Hi-Fi Products
Service Bulletin

Model: MHC-2750

No. 383

Subject: Tuner Crosstalk at Phono Input

ST-H2750

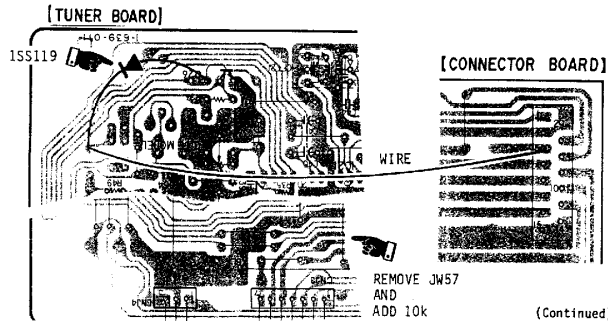
Tuner crosstalk at the Phono input.

Solution: If the customer complains of tuner crosstalk or bleedthrough on the phono input perform the following countermeasure.

- 1) Remove JW57 and insert a 10K ohm 1/4W resistor (1-249-429-11) in its place.
- 2) Add a 1SS119 diode (8-719-911-19) and a wire to pin 5 of CNJ601 (connector board) as shown.
